Southern California Edison
Banducci PTC A.12-11-011

DATA REQUEST SET A1211011 Banducci CPUC-SCE-002

**Banducci Substation
300 ft. Ownership List**

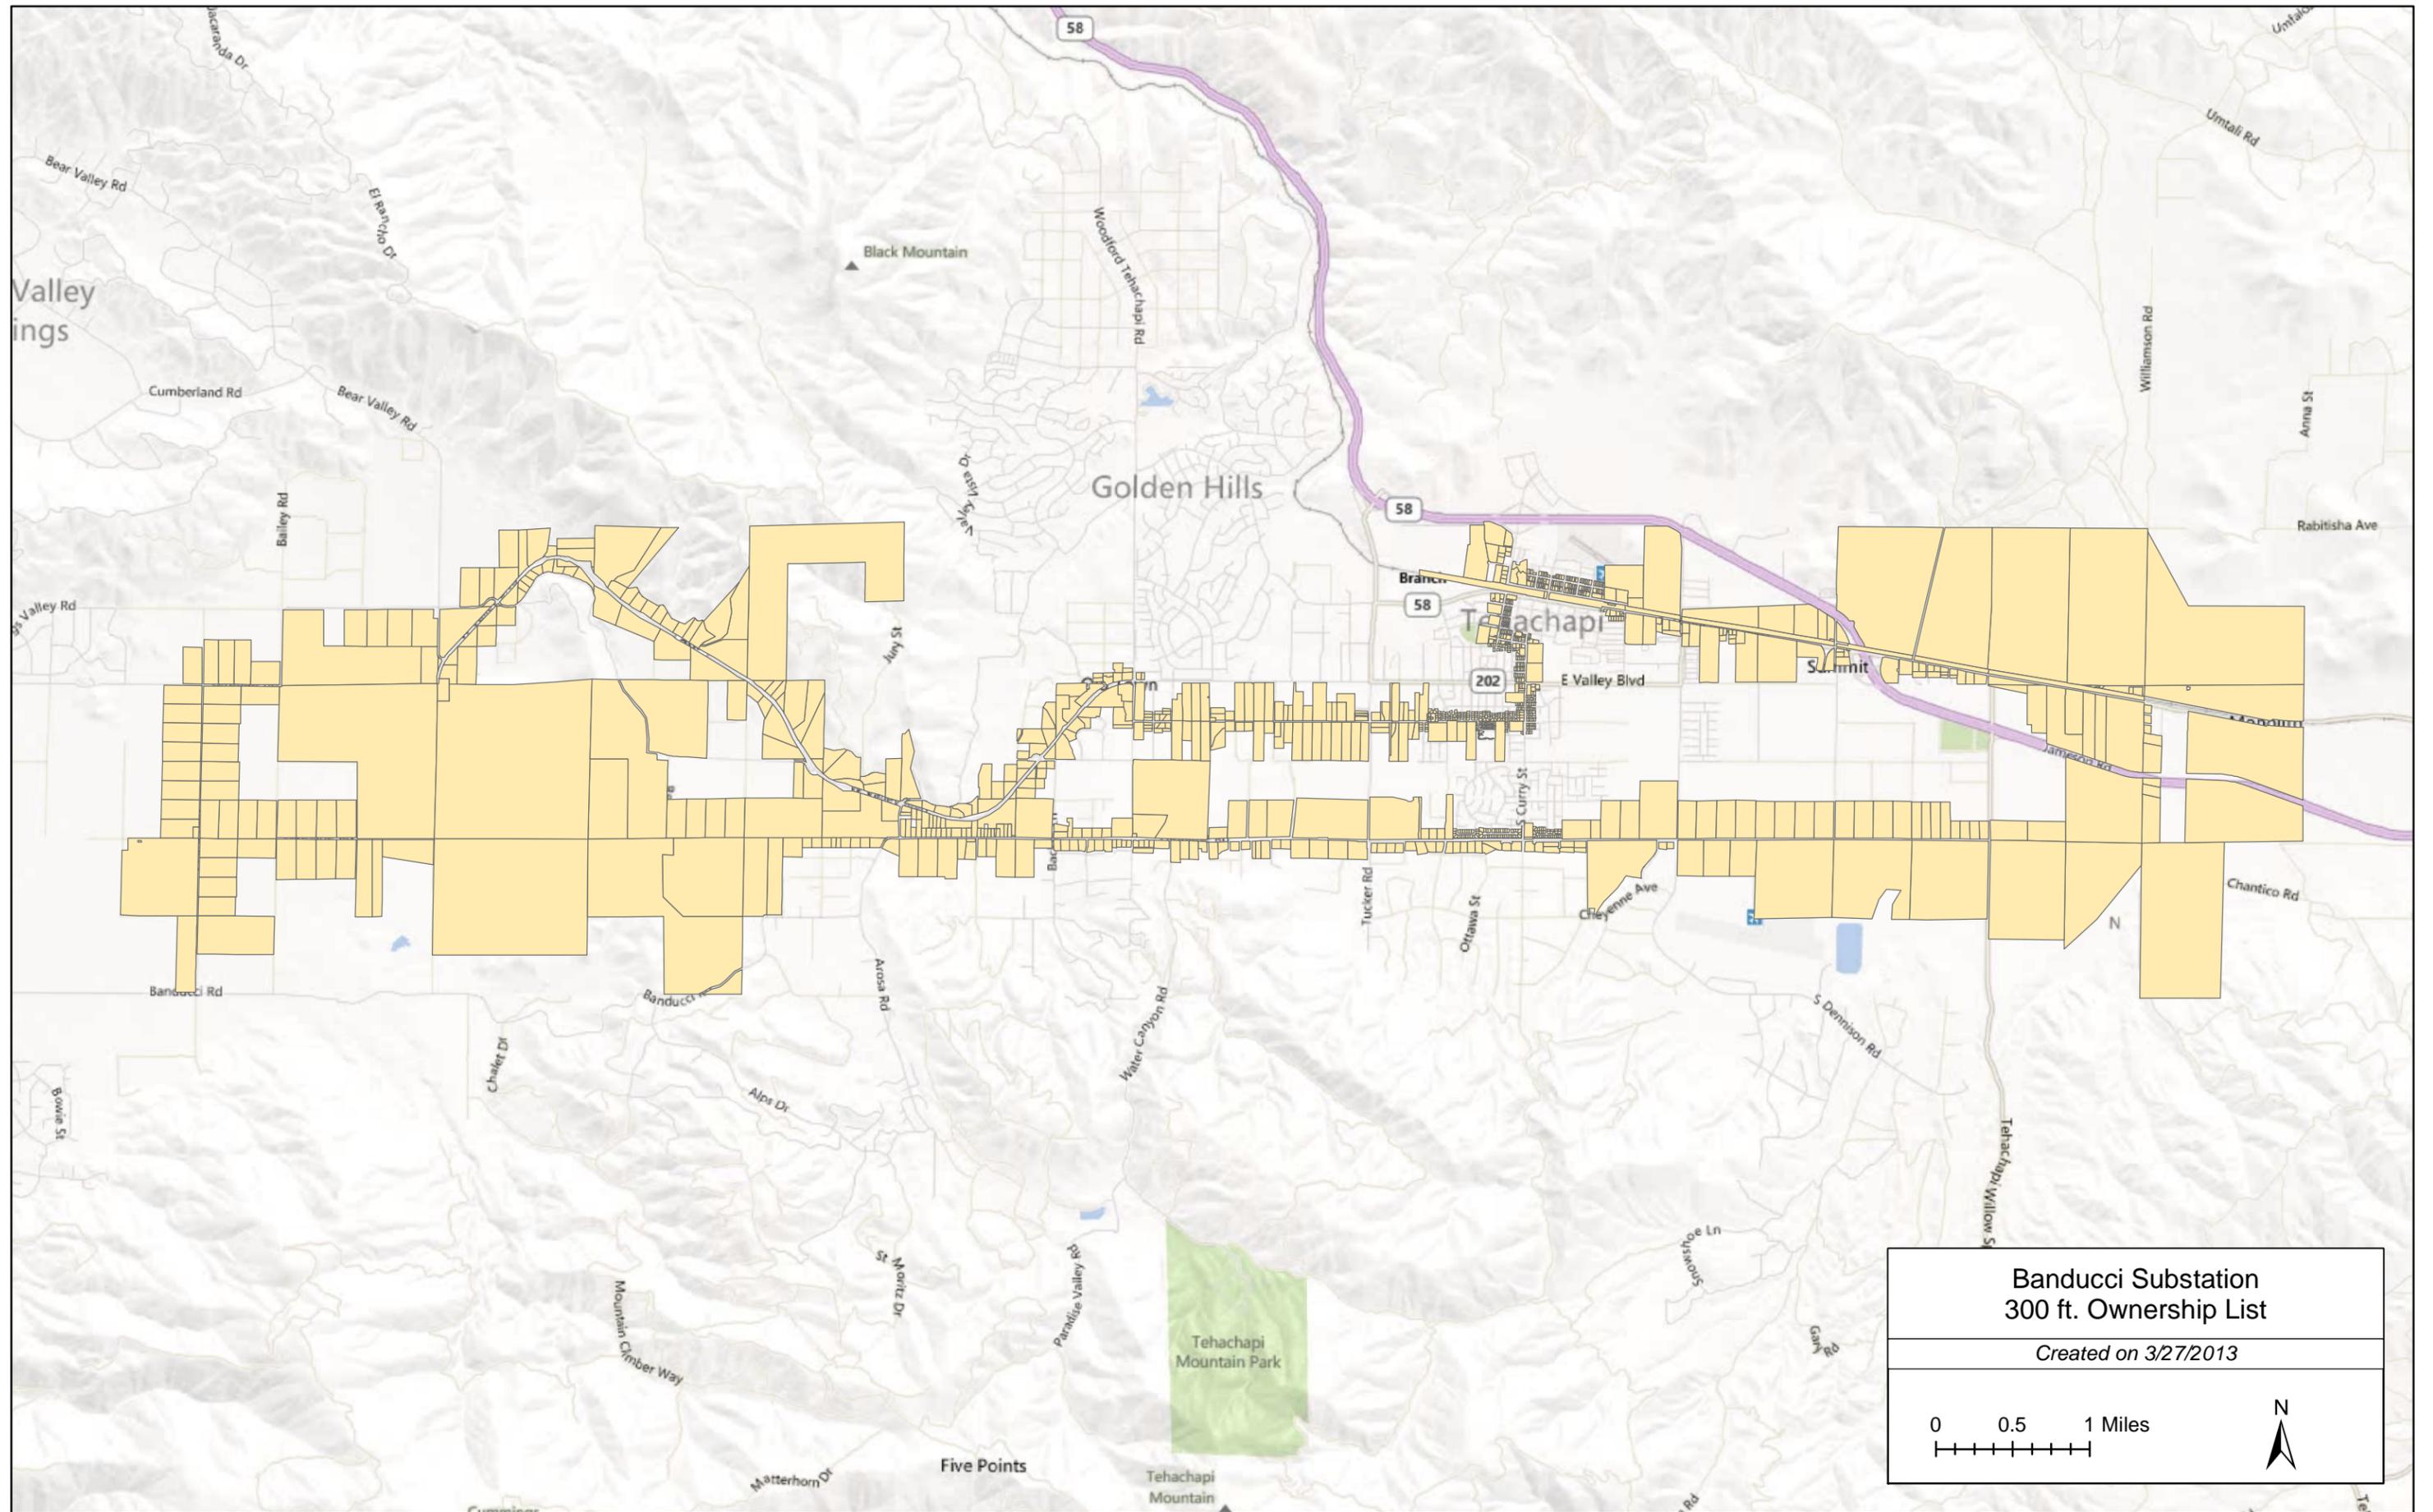
I previously requested an Excel spreadsheet with all parcels within 300 feet of the proposed project components. SCE provided an excel spreadsheet with the requested information for only those parcels within 300 feet of the substation footprint. The same information is required for parcels within 300 feet of all project components, including laydown areas, subtransmission lines, and telecom construction activities (constituting hundreds of parcels). Please provide this information with the PEA resubmittal.

Subject to final engineering, attached is a list of parcels within 300 feet of all project components in Excel (information obtained from the current Kern County Assessor's Office). Each component of the project is listed separately by worksheet tab. A general vicinity map depicting the parcels in the list is also attached.
